AGENDA PORTLAND PLANNING BOARD MEETING

To: Chair Mazer & Members of the Planning Board
From: Jimmy Dealaman, Planner
Date: March 5, 2021
Re: Presumpscot Elementary School Addition & Renovations Project
Project ID: PL-001297-2020, CU-001329-2020
Meeting Date: March 9, 2021
CBL: 425 A007, 428 F013, 427 1001

Portland Public Schools has applied for a Conditional Use and a Level III Site Plan approval to facilitate the development of two new building additions, totaling 17,910 square feet, to the existing Presumpscot Elementary School located at 69 Presumpscot Street in the East Deering neighborhood.

EXISTING
SITE CONDITIONS PLAN

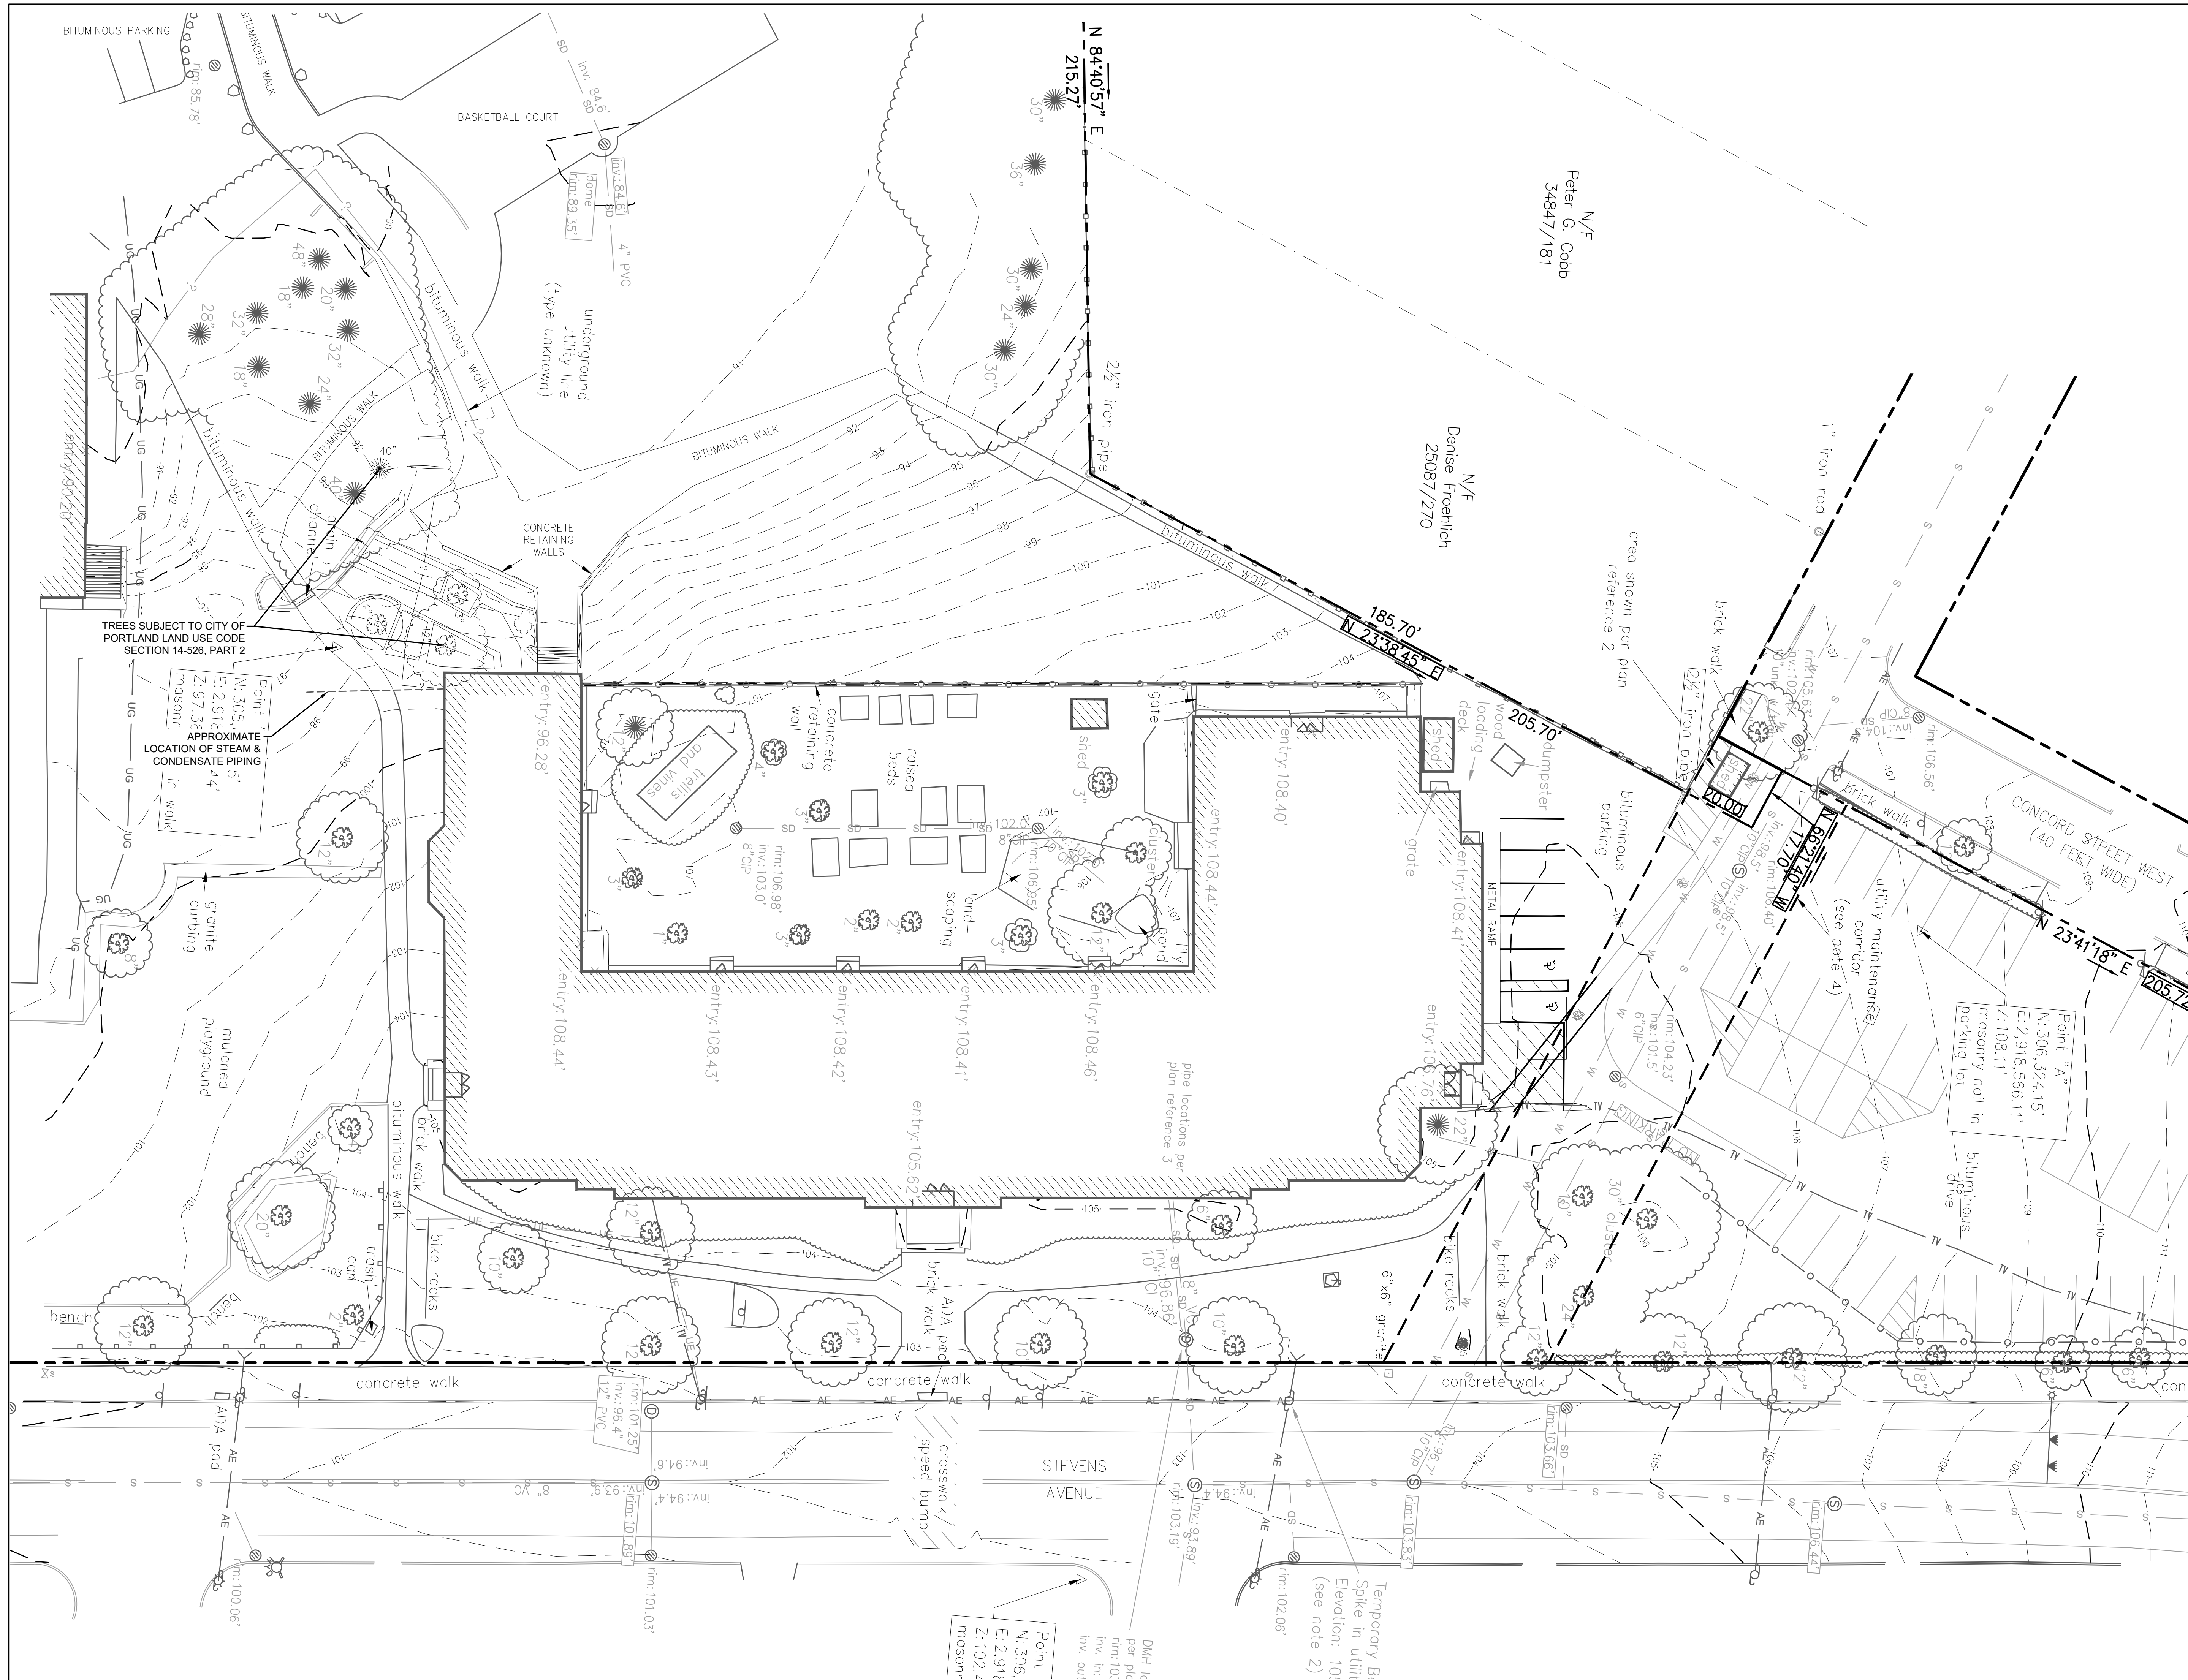
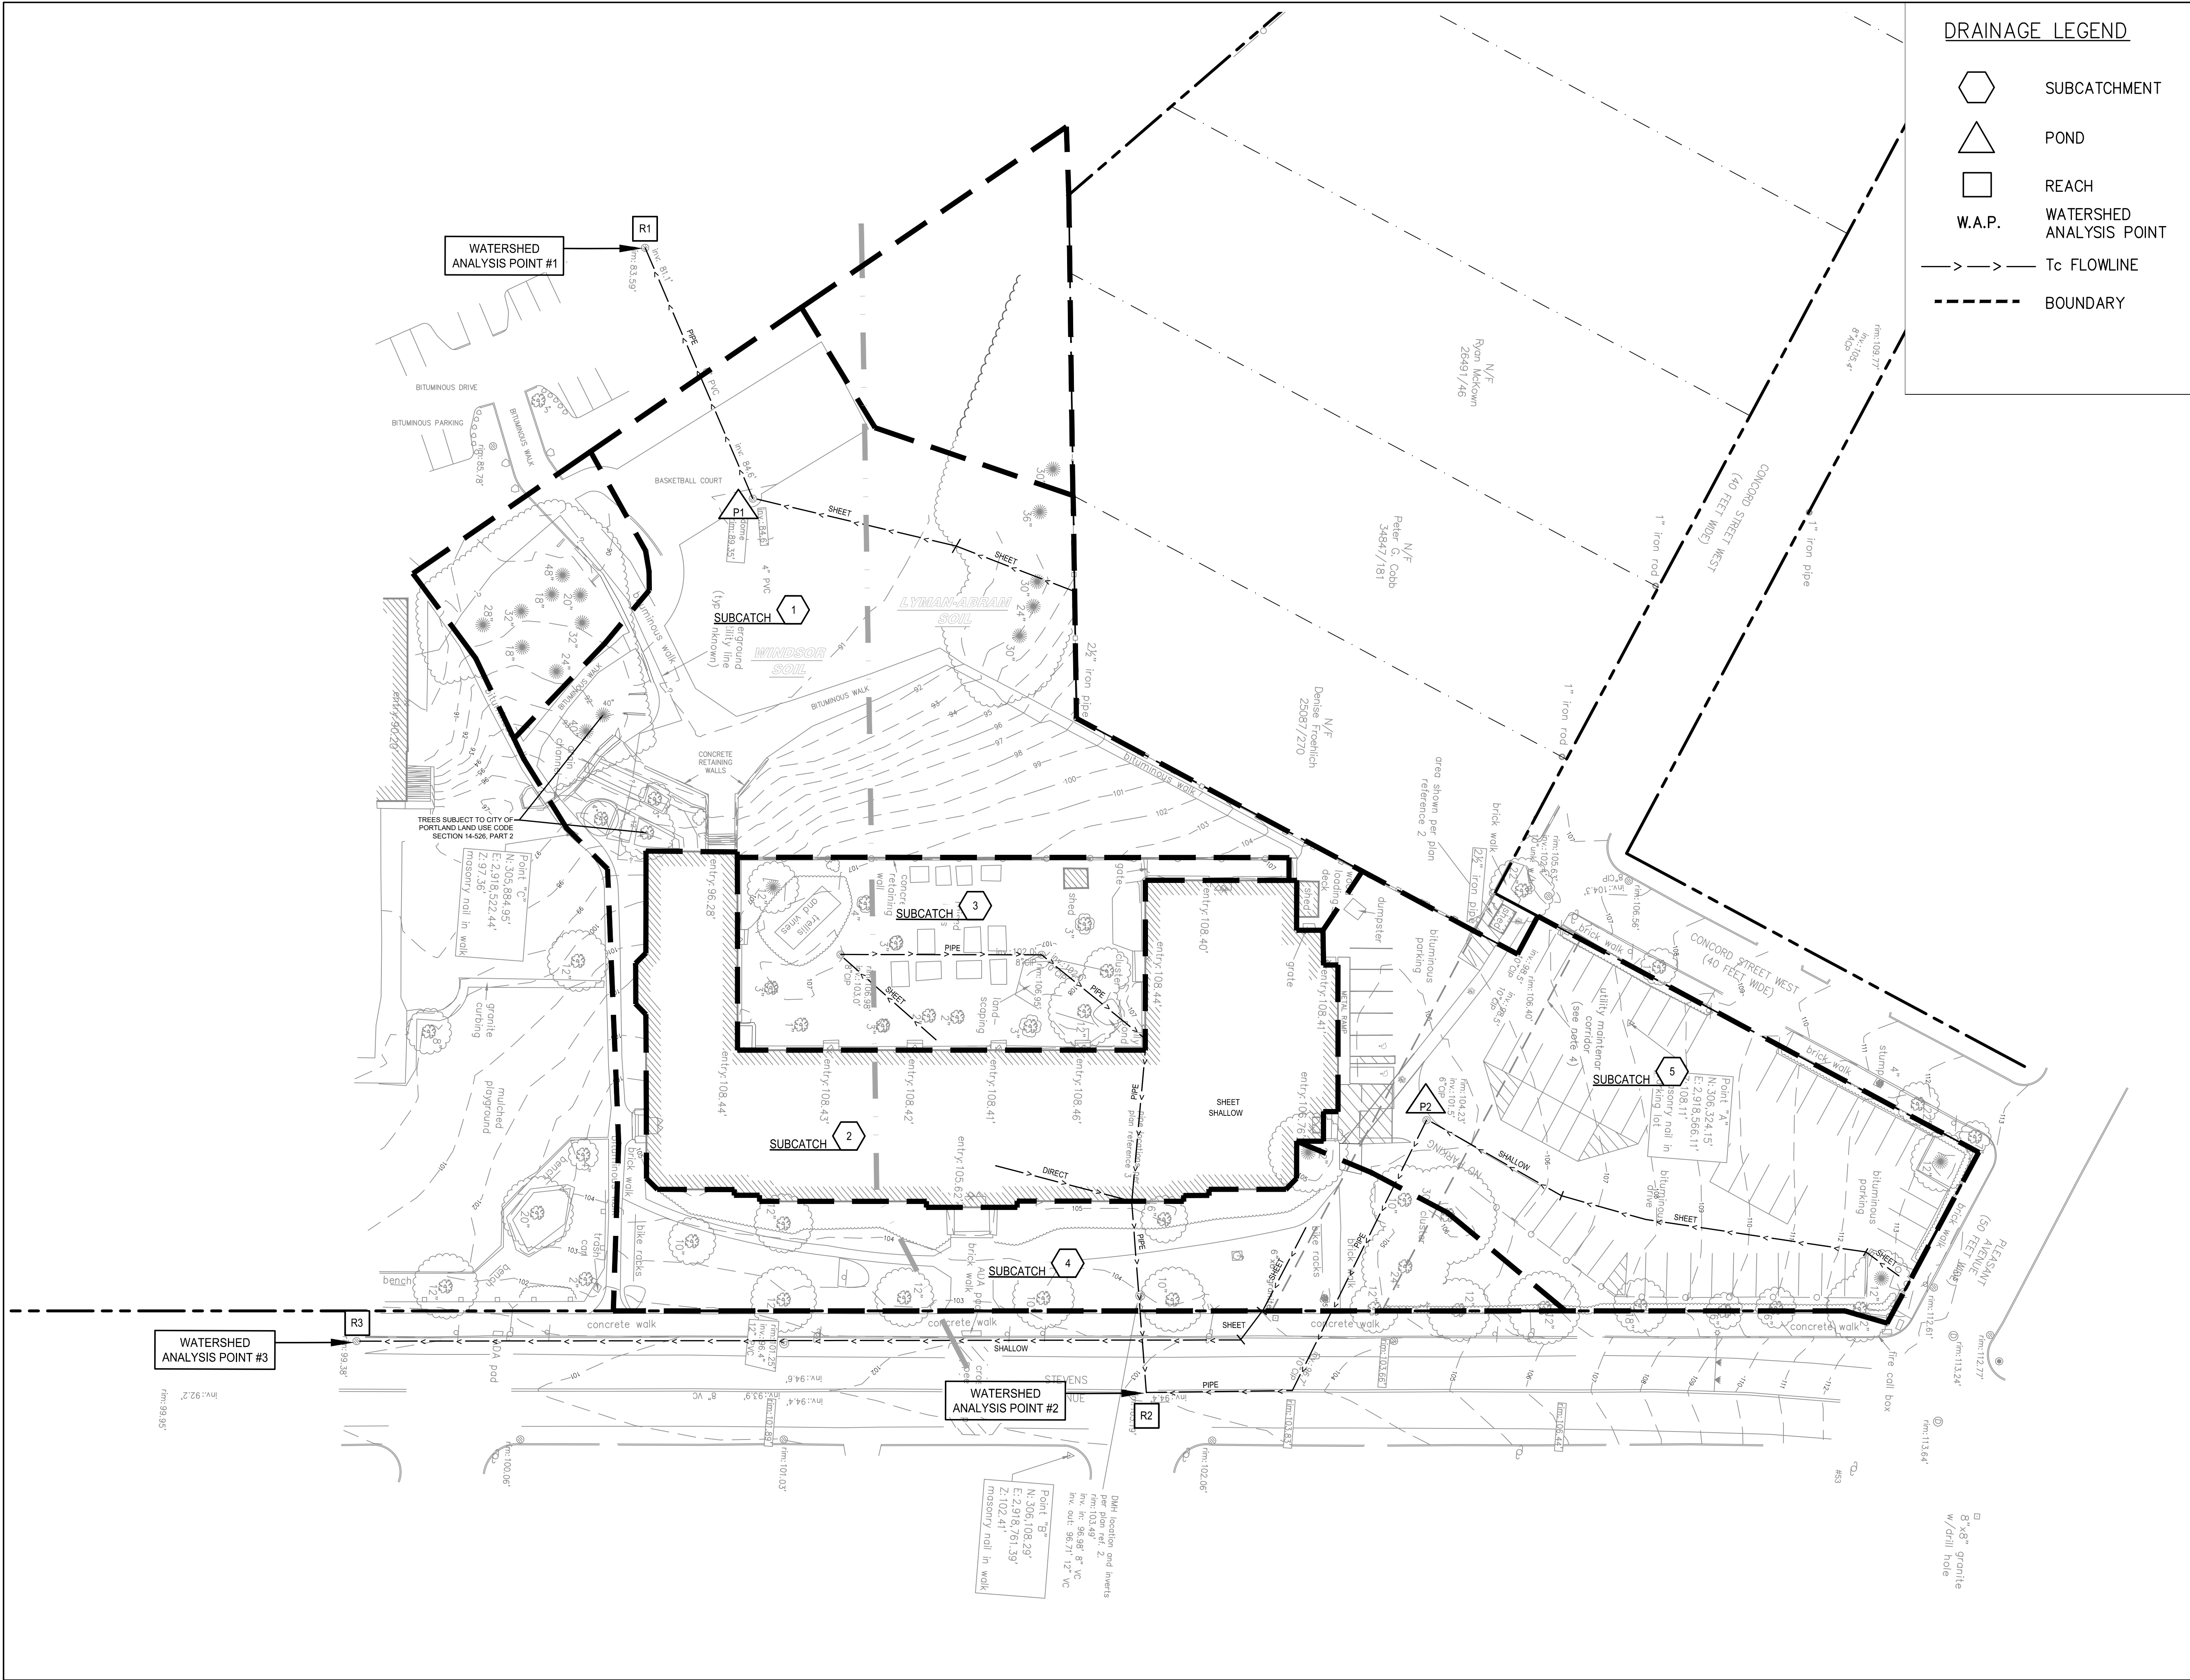
21. The tree-clearing limits are shown as no more than necessary for the required paved fire lane and embankment grading slopes.
22. Trees to be removed that are 10" diameter or larger have been added to drawing C10-1 Existing Conditions Plan.
